GENERAL LEASE - RIGHT-OF-WAY USE

APPLICANT: The Cultured Abalone, Inc.
2927 De La Vina Street, Suite C
Santa Barbara, California 93105

LAND USE: Three (3) eight-inch-diameter intake pipelines
and one (1) 12-inch-diameter discharge pipeline
for a mariculture facility.

COUNTY OF SANTA BARBARA
DEPARTMENT OF RESOURCE MANAGEMENT
PROPOSED NEGATIVE DECLARATION

Location of Project Area

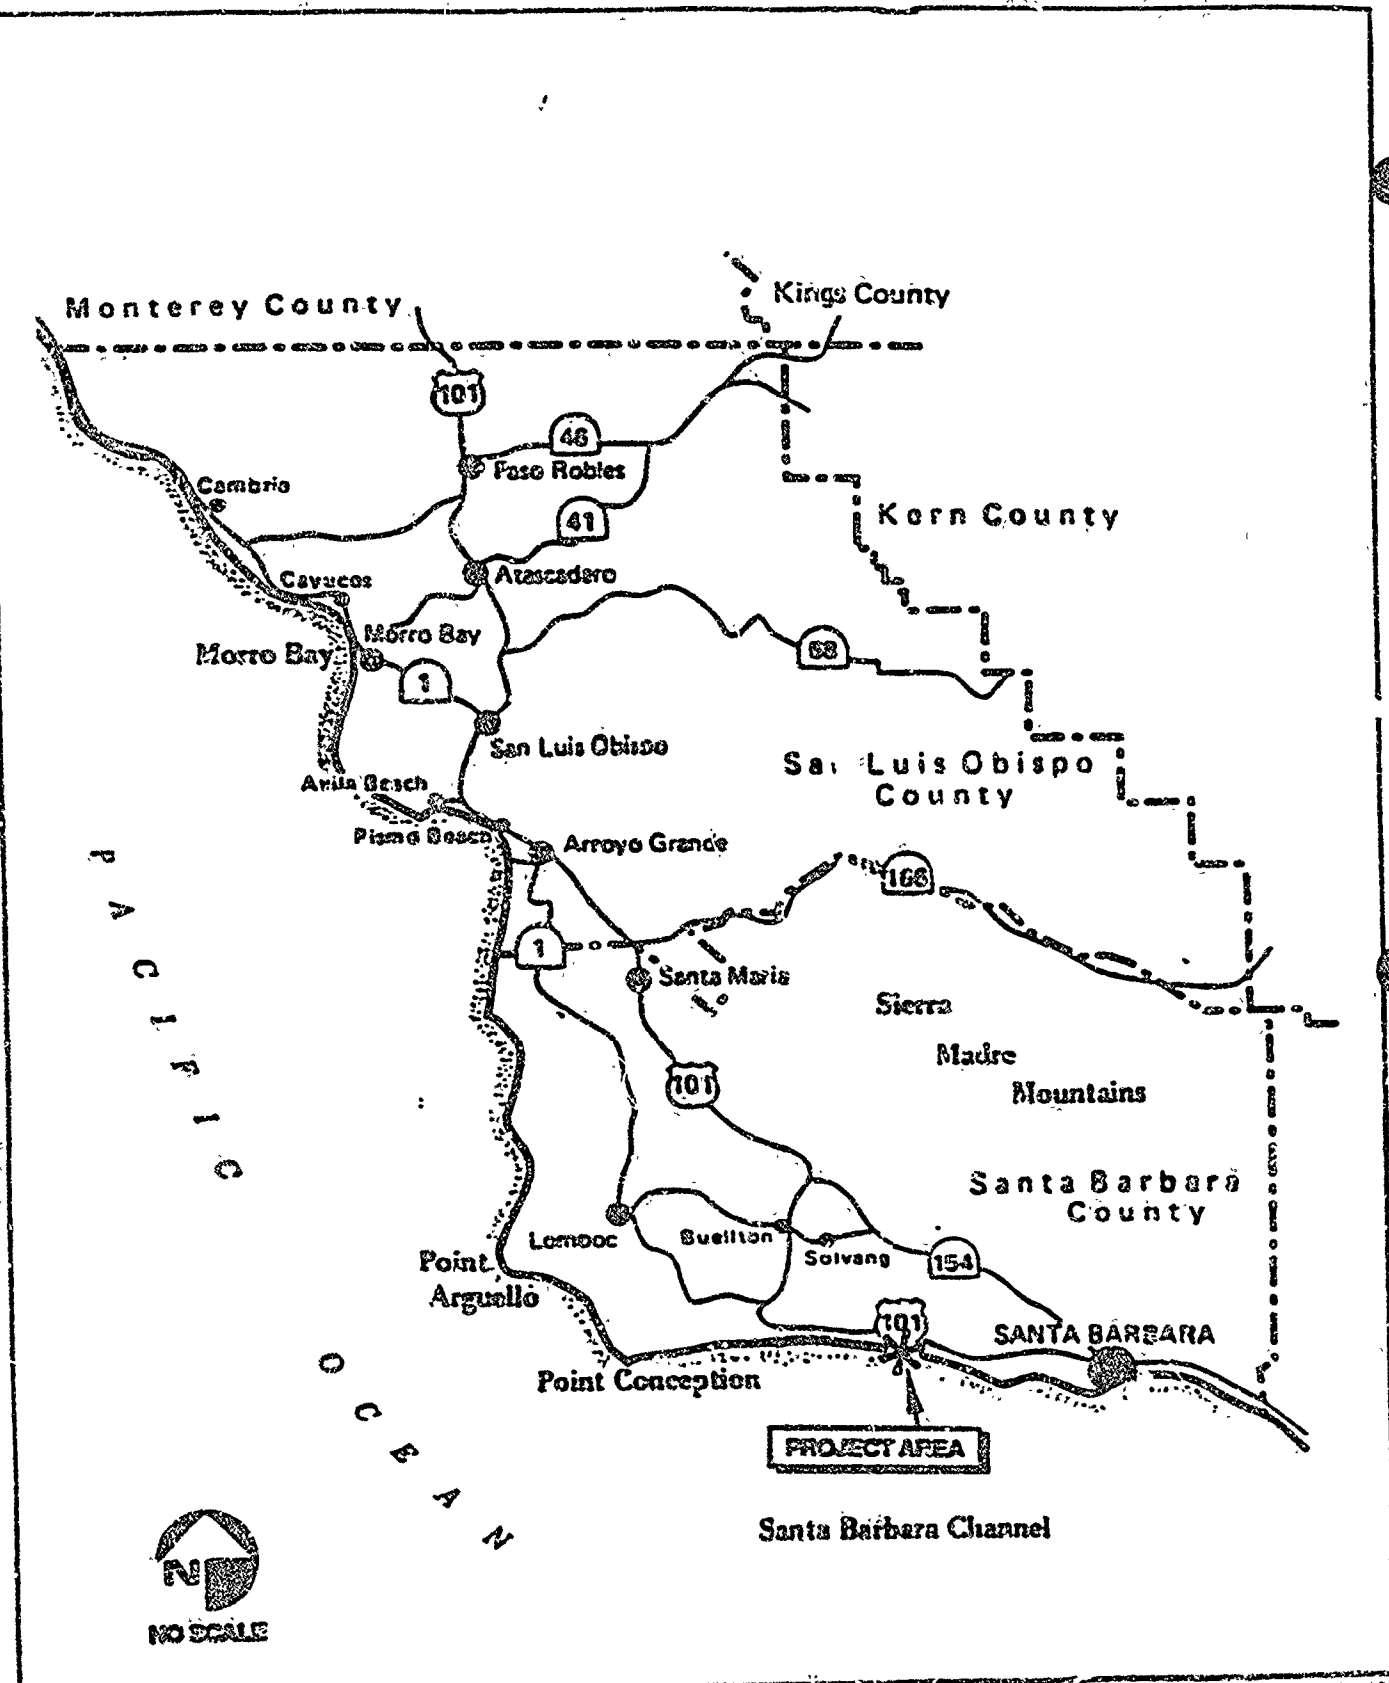
1. Page 2, Figure 1: the project area is shown to be close to Tajiguas. It should be located eastward, approximately where the 101 sign is.
2. Page 4, paragraph 6: there will be a maximum of 634 cubic yards of fill needed. We will not be cutting from the project site due to the archaeological sensitivity of the area.
The two bathrooms will be located in the hatchery, not in the trailer.

Development Area Site/Grading Plan

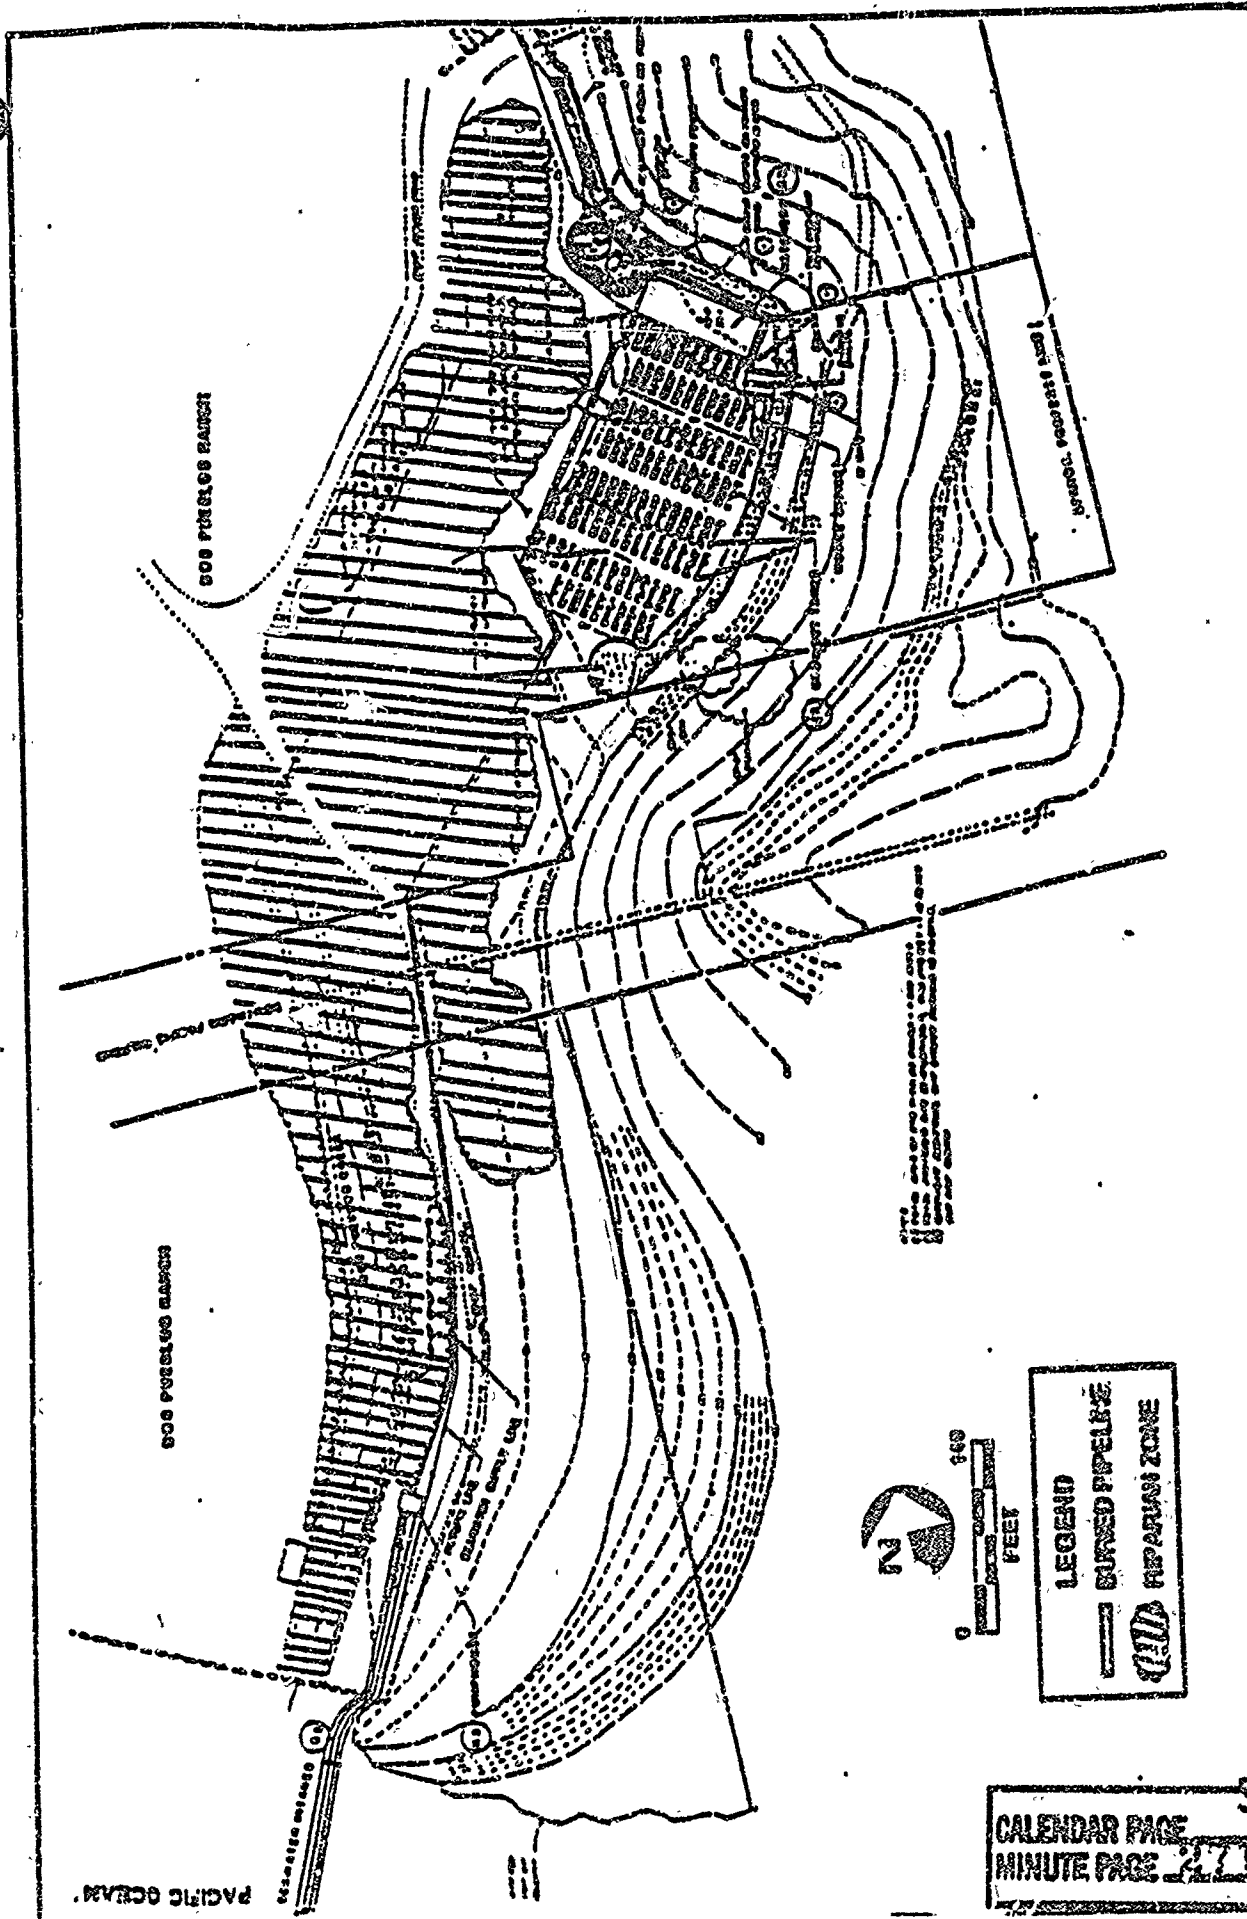
In comment to the above Proposed Negative Declaration, please be advised that the Site Access Road, as shown on Figure 2 is unavailable for use for this project at this time. This is due to a restriction placed on the underlying property through an easement held by us and other Naples property owners that will not allow the road to be used as primary access to this Project site or the land around it.

We are discussing this matter with Mr. Schulte's attorney and Mr. George Wilson, but as yet it is unresolved. We hope to resolve it but if we are unable to, an alternate access road would have to be created other than as illustrated in Figure 2.

Seawater Intake Pipeline Profile

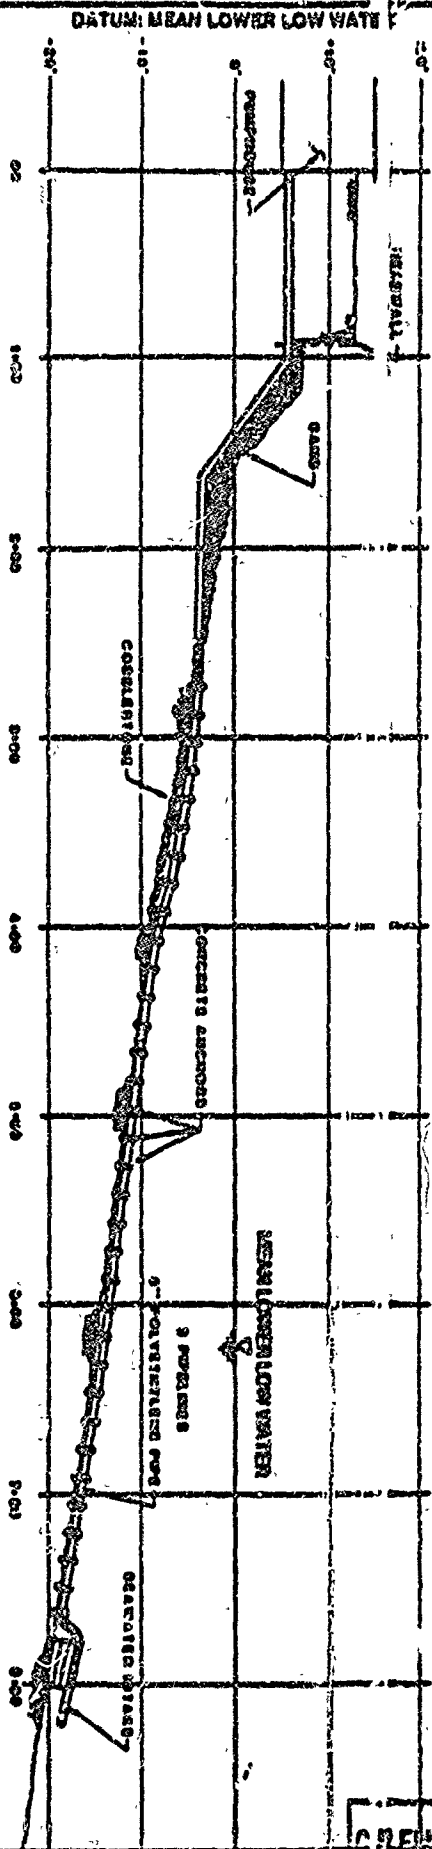
7. Page 12, last paragraph: Cobblestone exposed in winter extends seaward from the headwall. Figure 3 should have been drawn showing the cobblestone under the sand extending up to the headwall.
